# Project T10/1826-D

## Information technology - SCSI / ATA Translation - 2 (SAT-2)

# Summary of Comments on SCSI / ATA Translation Standard

Figure 2 — ATA document structure

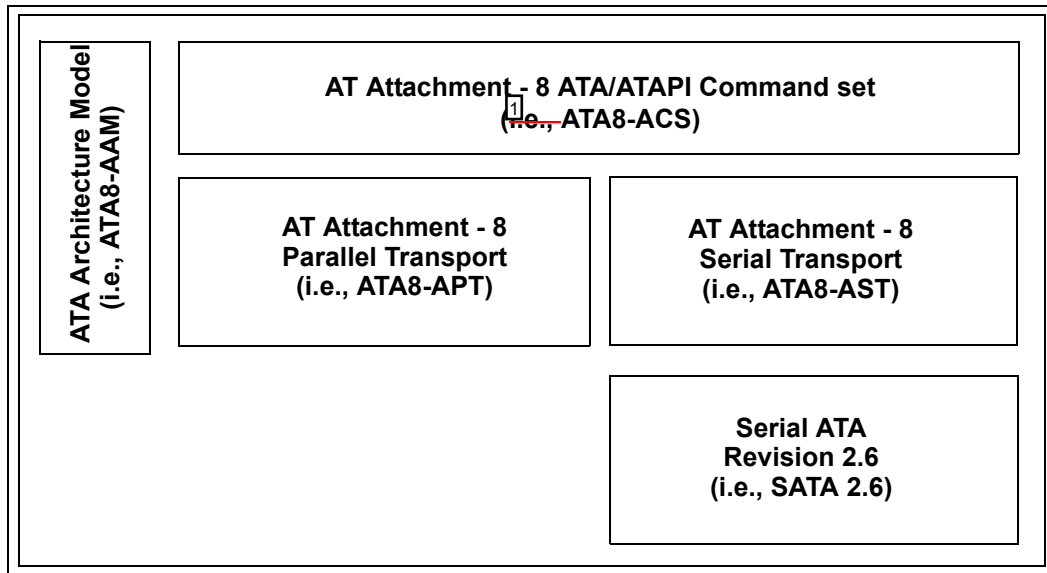
Delete all the "i.e.,"s from figure 2. That is not used for acronyms in parenthesis - just the acronym is fine, like "(ATA8-ACS)"

moverby Accepted 9/11/2008 11:33:18 AM -07'00'

Figure 3 — SCSI / ATA Translation document role

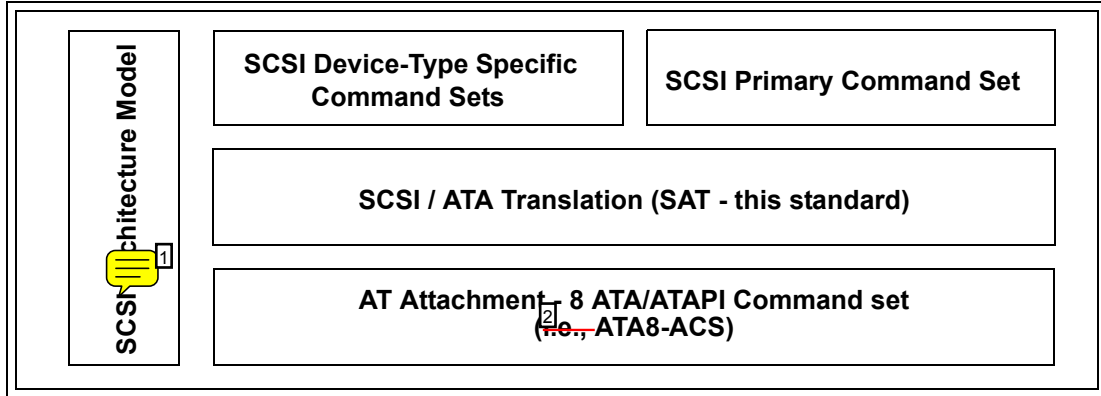
Number: 2 Author: HPQ-RElliott Subject: Cross-Out Date: 9/3/2008 9:42:24 AM -07'00'  
Delete i.e., in figure 3 (see reasoning in comment on figure 2)

Figure 5 — SATL contained within a SCSI to ATA protocol bridge

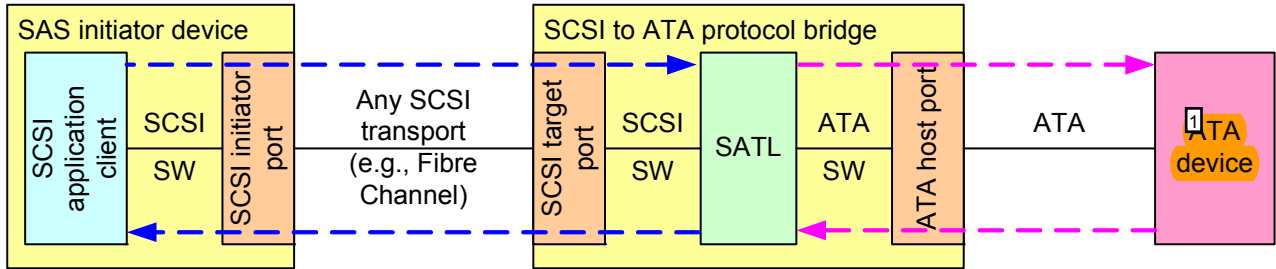
Change these 3 "EXAMPLEs" back into standard paragraphs.

Rejected - was discussed and there was not a need seen to make the change.

**Figure 10 — Translation of Logical Sector Alignment (part 3)**

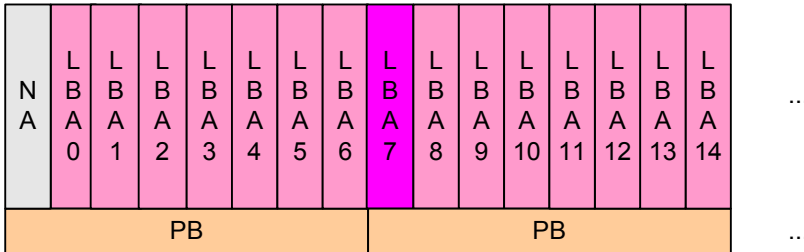
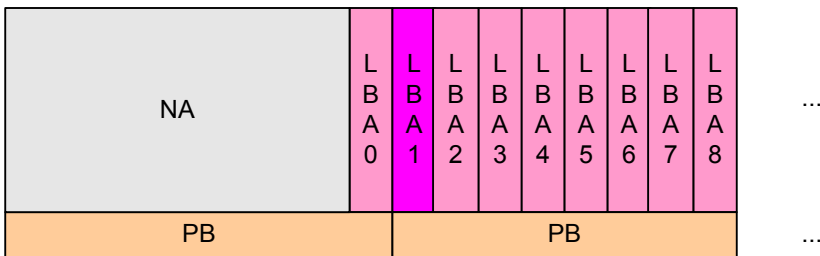
Number: 1 Author: Kevin\_Marks Subject: Highlight Date: 8/11/2008 12:51:30 PM -07'00'  
Figure 10 missing reference in text
